Dr. William Shack
Chairman
Subcommittee on Material, Metallurgy & Reactor Fuels
ACRS U.S. Nuclear Regulatory Commission
Washington, D.C. 20555-0001

Final Report
on
Review of Oyster Creek Generation Station
3-D Drywell Confirmatory Analyses

Figure 1 Approximation of buckling mode shape

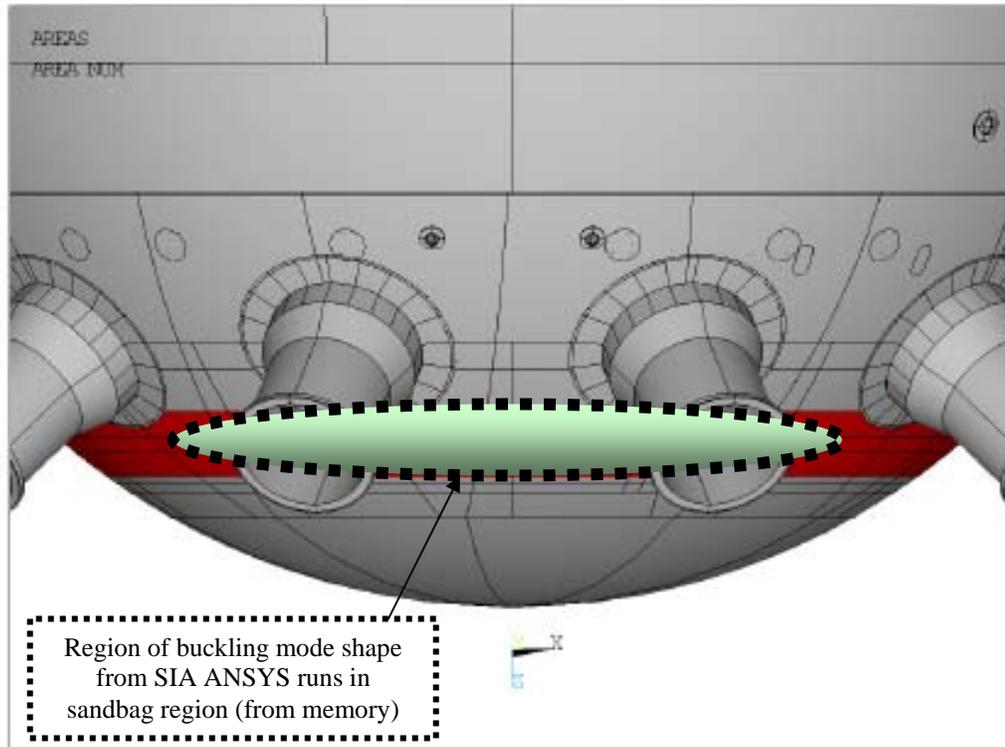
Because a full finite element model of the entire drywell shell was developed and modeled, buckling concerns of the entire shell (not just the corroded areas) were considered. However, many of the 200 buckling modes were in areas of the model that did not have degradation and there were low load participation factors. Exelon also said that not all of the loads in the toroidal area and vent lines were included in the model, so buckling modes in those areas are not relevant. It would have been of great assistance to have some comments added to the buckling mode tables (8-2 and 8-3 in SIA January 2009 report) that noted where the buckling occurred, or elimination of non-relevant buckling modes. Furthermore knowing the shape of the buckling modes of primary concern is quite helpful in understanding the thickness sensitivity studies. Having a copy of the pertinent buckling shapes from the SIA work is desirable. (Those mode shape figures were passed around at the September 29th meeting to the ACRS staff and G. Wilkowski, and Figure 1 is an attempt to illustrate the buckling mode shape of interest.)

Figure 2 Thickness reduction measurements, SIA idealized circular reduced thickness areas, and blue dashed ellipses suggesting larger local thinned regions

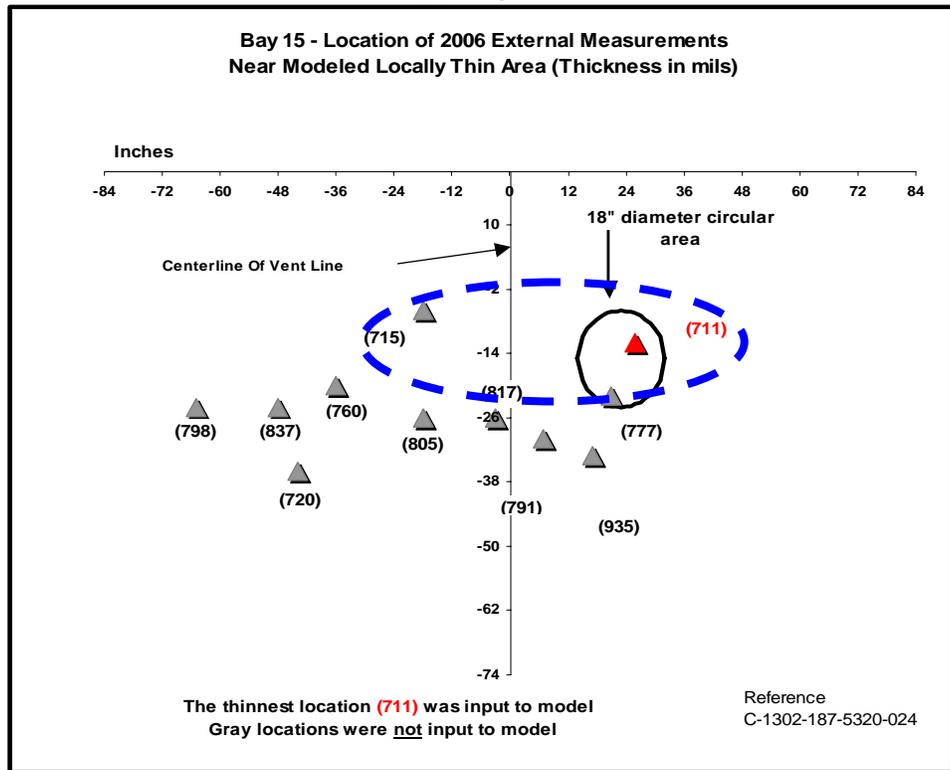
In regards to the thickness measurements and how they were modeled, at the September 23, 2009 meeting several of the ACRS staff members and the EECL presenter noted (as I did) that some of the thickness measurement plots in the Exelon presentation suggested that the thinned region might be more elliptical in shape (longer in the circumferential/horizontal direction) than the circular areas used in the SIA FE model. In particular this could be seen for Bay 19 (VG 26) and Bay 15 (VG 29). These longer elliptical shapes (illustrated in my Figure 2) would be in the same direction as the buckling mode shape in the sandbag region.
